Response to Submissions Report
Budawang School
SSD-8845345

On behalf of
NSW Department of Education
July 2021

Figure 1. Location of additional trees to be removed (Source: Group GSA)

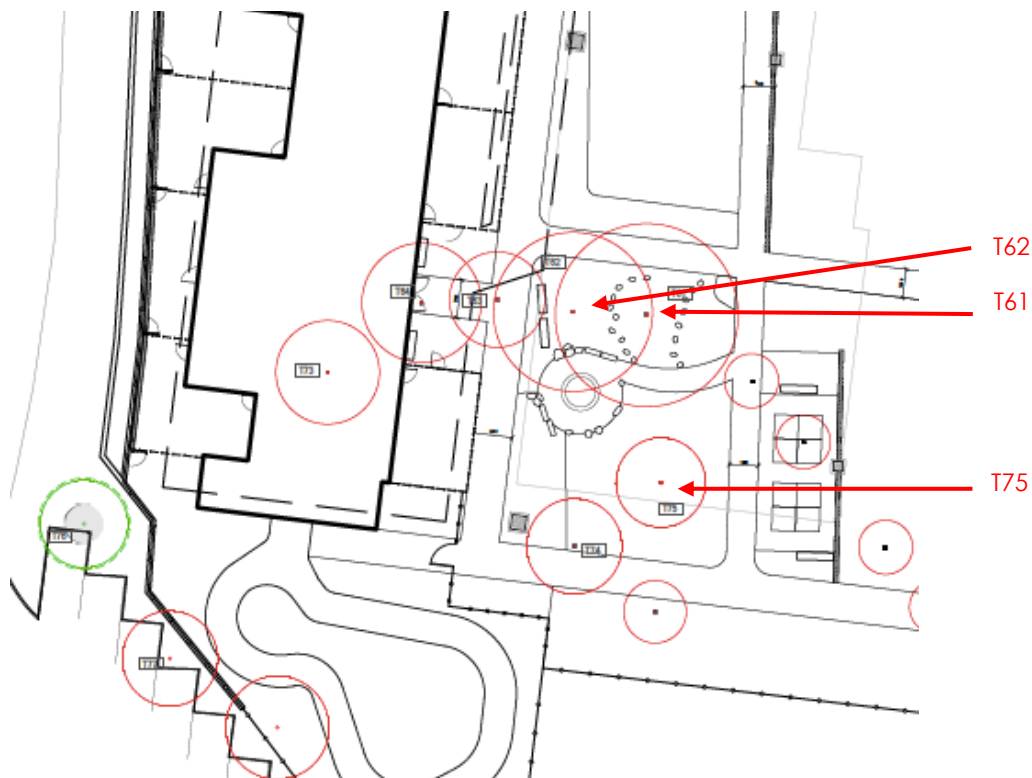
Proposed change	Reason for change
Removal of three additional trees within the central courtyard, namely T61, T62 and T75 as identified in the arborist report. T61 and T62 are both Grey Gums with a height of approximately 18m, and T75 is Narrow Leafed Paper Bark with a height of 6m. Figure 1 below the table show the location of the additional trees to be removed.	Given the special nature of the proposed school, T61 and T62 have been deemed by DoE as posing an unacceptable safety hazard associated with use of fallen limbs as weapons. Re T75: As discussed in the following row, the levels around the central courtyard were significantly manipulated in the original design to retain T61 and T62. Now that the T61 and T62 are being removed, the levels are being rationalised to avoid unnecessary decking and potential drainage issues. The rationalisation of levels will

Proposed change	Reason for change
	<p>likely adversely affect T75, and therefore this tree is proposed for removal. It is noted that T75 is relatively small and has only medium retention value, and therefore removing the tree to provide for appropriate courtyard levels is considered a reasonable outcome.</p> <p>It is noted that, despite the additional tree removal, the proposal still provides for significant new plantings, with approximately 23% of the site to be covered by tree canopy.</p>
<p>Re-alignment of the pathways across the central courtyard. The central pathway is moving to square up the playground spaces.</p> <p>The realigned pathways are shown in the plan extract at Figure 2 below the table.</p>	<p>Related to the above change, retention of the central courtyard trees required manipulation of the levels around the trees. This caused a dip in the landscape that was managed through the use of decking, but this solution would result in potential drainage issues. Given the trees are now proposed for removal, the level issue is being resolved to avoid the dip and any issues associated with water ponding.</p>

Figure 3. Updated entry gate location to south of roundabout (Source: Group GSA)

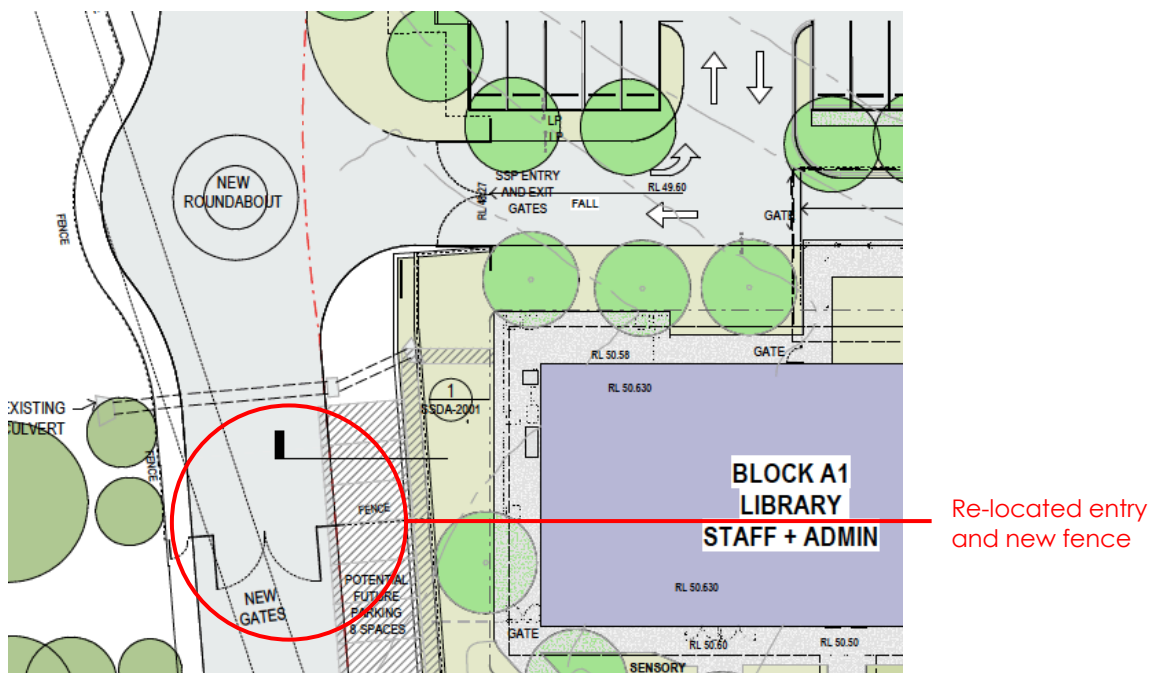
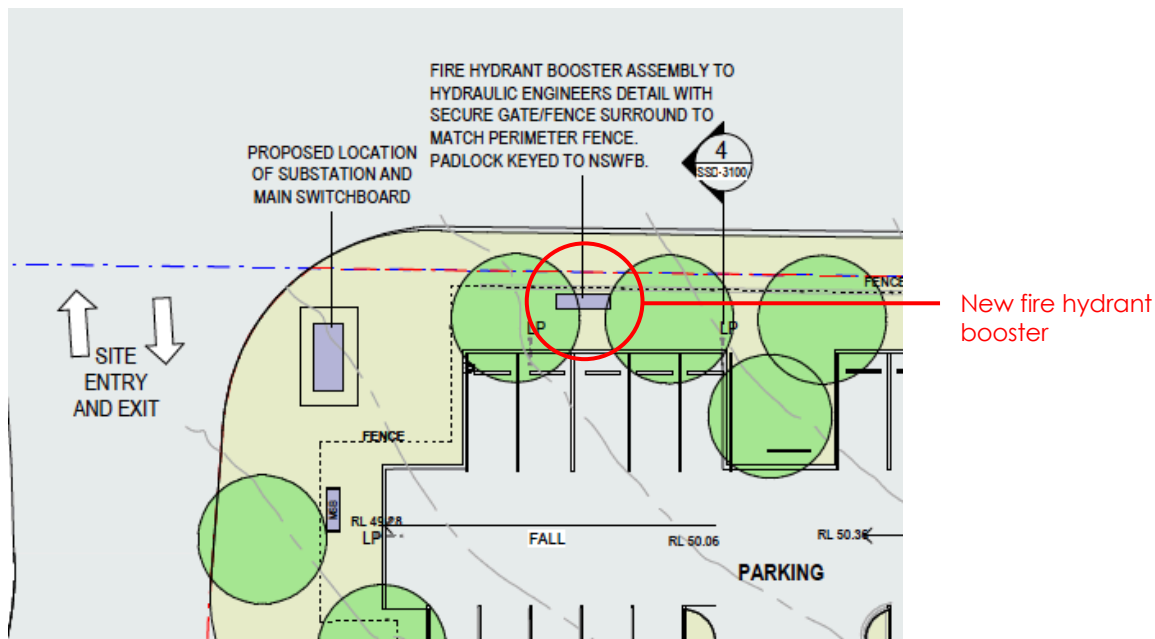
Summary of issue/comment	Response
<p>Location of entry gates</p> <p>The entry gates on the main road should be located to the south of the roundabout to enable the remainder of the former school site to be secured while public access is provided to the car park for after hours use of the hydrotherapy building.</p>	<p>Council's suggestion has been incorporated in the updated plans. The entry gates on the main road have been moved to the south of the roundabout. As Council notes, this allows for the remainder of the site to be secured while public access is provided to the car park for after-hours use of the hydrotherapy building.</p>
<p>Section 68 application</p> <p>No Section 68 application has been lodged for consideration.</p>	<p>A Section 68 application will lodged for any work covered under Section 68 of the Local Government Act 1993 as required.</p>
<p>National Construction Code (NCC)</p> <p>No National Construction Code (NCC) assessment has been completed. The submitted NCC indicates compliance is achievable, and the proposal may be subject to performance-based solutions.</p>	<p>This is correct. It is expected that compliance with the NCC will be required as a condition of consent.</p>

<p>Entry gate moved from north of proposed roundabout to south of roundabout. Fencing has been added to the west of the existing pathway due to relocation of the site gate.</p> <p>The updated entry is shown in the plan extract at Figure 3 below the table.</p>	<p>This change has been made in accordance with a recommendation by Council in its submission. The new gate location allows for the remainder of the site to be secured while public access is provided to the car park for after-hours use of the hydrotherapy building.</p>
<p>Hydrant booster has been added along the Croobyar Road frontage. The location is shown in the plan extract at Figure 4 below the table.</p>	<p>The booster has been added in accordance with advice from the hydraulic engineer. The booster will not result in any significant visual impacts and will not require tree removal.</p>
<p>Two additional trees added along Croobyar Road near substation.</p>	<p>This change was made in response to Council's comment regarding the apparent incomplete row of trees along Croobyar Road. This row of trees was previously "incomplete" due to concerns regarding clearance distances around the substation. The clearances have since been verified, and the two additional trees are outside of the clearance zone.</p>
